## RESPONSE TO REQUEST FOR ADDITIONAL INFORMATION

### APR1400 Design Certification

Docket No. 52-046

RAI No.: 182-8160  
SRP Section: 03.07.01 – Seismic Design Parameters  
Application Section: 3.7.1  
Date of RAI Issue: 08/31/2015

Figure 47 Raw One-sided PSD and Smoothed PSD of Time History of Truncated Duration from 2.8 sec to 11.0 sec for HRHF-VT

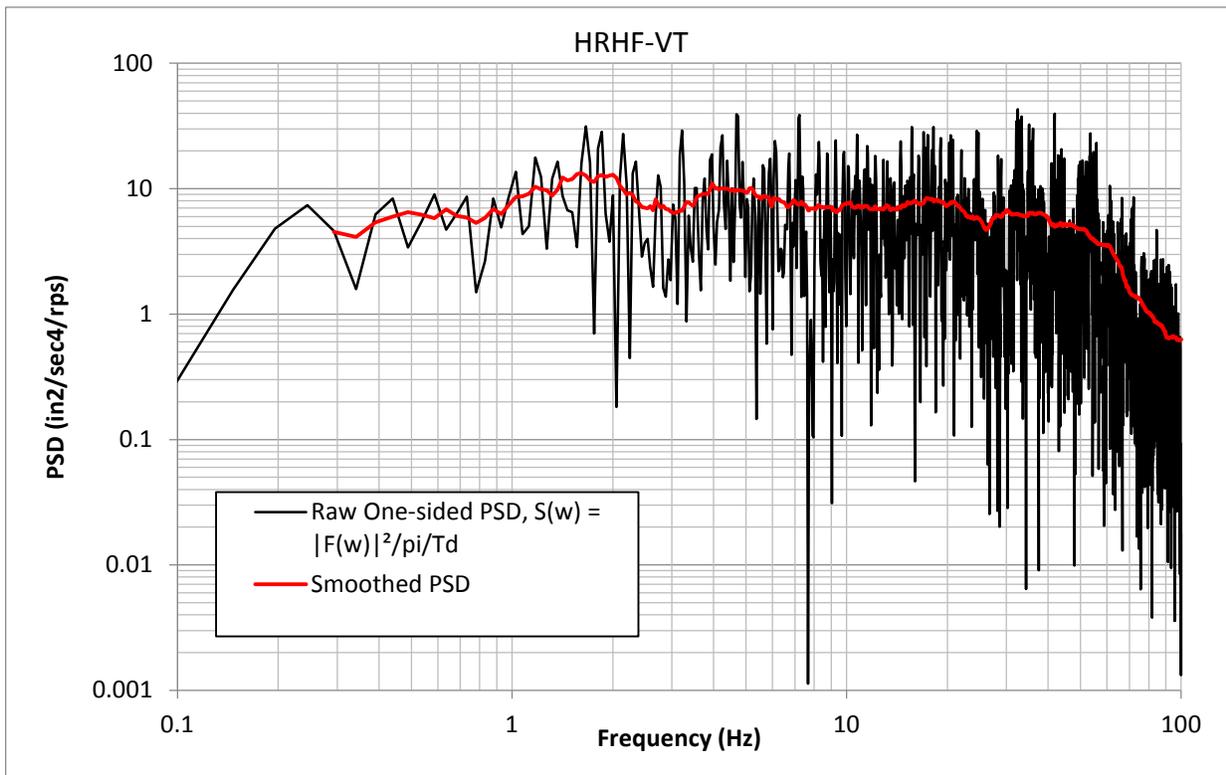
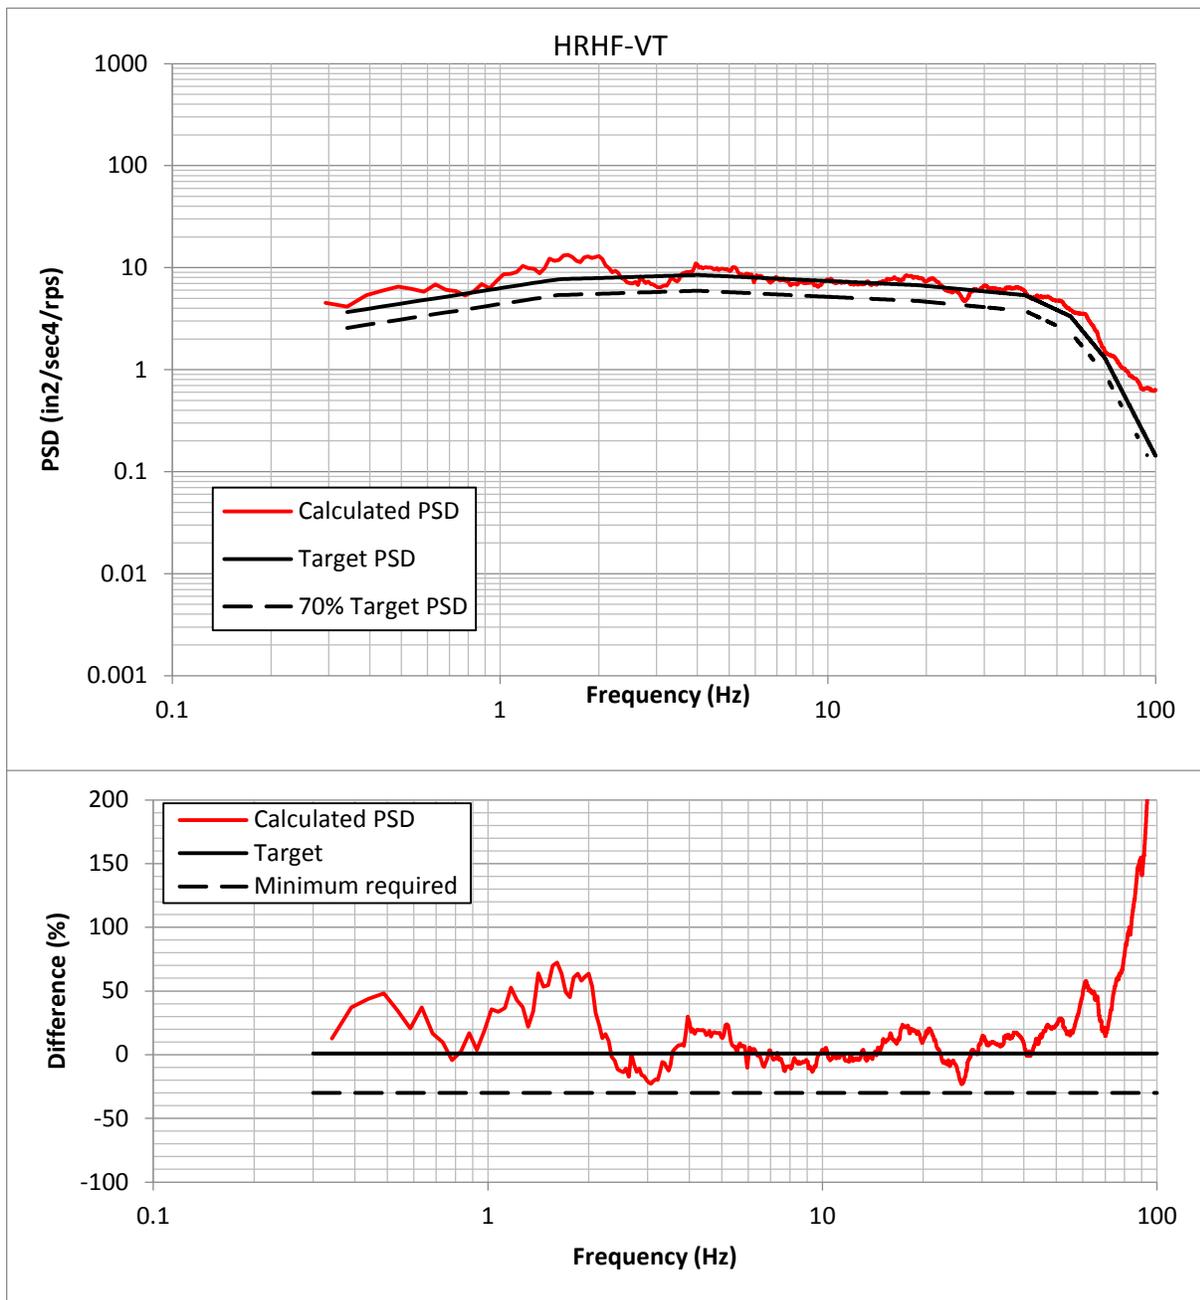
**b) Justification of the method used to estimate PSD for the HRHF time histories**

Section 3.5.3 of APR1400-E-S-NR-14004-P, Rev. 1, "Evaluation of Effects of HRHF Response Spectra on SSCs," describes the method used to calculate the PSD function from an acceleration time history. It utilizes an "equivalent stationary strong-motion duration" as the strong motion duration. The equivalent stationary strong motion is defined as the time for a P1-to-P2 rise of the cumulative Arias intensity, divided by (P2-P1). The applicant stated, "the equivalent stationary duration  $T_{is}$  for the entire time histories as determined from Eq. (3-3) is the duration over which the total energy of the time history is built up from 0 to 100 percent with the

constant slope S.” In this statement, the parameters P1, P2, and S are not defined. As such, the applicant is requested to provide these three parameters for the three HRHF acceleration time histories. In addition, it appears that the PSD estimate is very sensitive to the choice of P1 and P2; for example a P1=0 and P2=100% will lead to an equivalent stationary strong-motion duration  $T_s$  equal to the total duration of the time history. As such, the applicant is also requested to provide a justification for the values of P1 and P2.

Appendices A and B of SRP 3.7.1 indicate that PSD should be estimated based on the strong motion duration. Therefore, the staff requests that the applicant provide a justification for the use of equivalent stationary strong-motion duration. Similarly, the applicant is requested to explain why the entire time histories were used in the Fourier transform. The use of the equivalent stationary strong-motion duration, which is shorter than the entire duration as shown in Figure 3-27 of APR1400-E-S-NR-14004-P, Rev. 1, together with the entire time history used in the Fourier transform, may overestimate the PSD for those frequencies that have very low magnitude but span the entire time history

The PSDs for the HRHF RS compatible time histories are computed using the procedure which is described in response to Question 03.07.01-3 (a) as shown in Figure 37 through 48. The PSDs for the HRHF RS compatible time histories satisfy requirement of Appendix B of SRP 3.7.1, Rev. 4 as shown in Figure 42, 45, and 48.
